Memorandum

DATE: September 23, 2025

SUBJECT: Office of Planning Report for Large Tract Review Case No. 2025-01
4801 Sargent Road NE (corrected)

SUBJECT: Large Tract Review 2025-01 – 4801 Sargent Road NE

Figure 1 | Site Plan

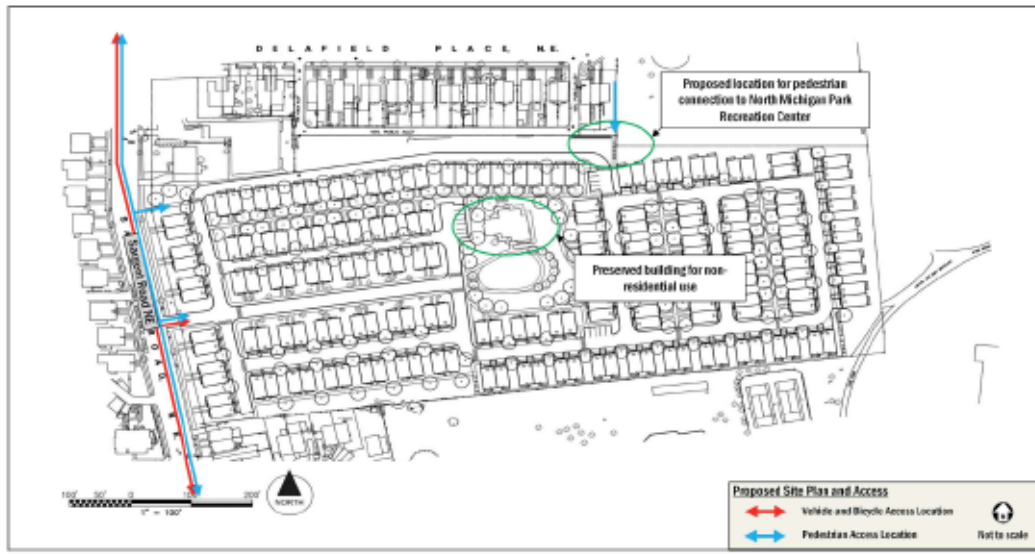
- A network of internal private streets and alleys, available for public use via a public access easement, will connect the houses. Each private street will contain a six-foot sidewalk with buffer, which DDOT strongly supports;

- Although bicycle parking is not required for the residential portion of the development, the Applicant proposes to provide 10 short-term bicycle parking spaces on site for visitors and deliveries to the site, which DDOT supports.

While the preliminary streetscape plans are generally consistent with DDOT standards, there are several outstanding issues that need to be reviewed in greater detail and resolved prior to the issuance of a public space permit:

- Submit a detailed curbside management and signage plan, consistent with current DDOT policies. If meter installation is required, they will be at the Applicant's expense;

- Continue to coordinate with DDOT's Urban Forestry Division (UFD) and the Ward 5 arborist regarding the preservation of any Heritage Trees and Special Trees, removal of street trees, and planting of new street trees in bioretention facilities or a typical expanded tree planting space. According to the District's [Tree Size Estimator map](#), the property has several trees the size of Heritage and Special Trees.
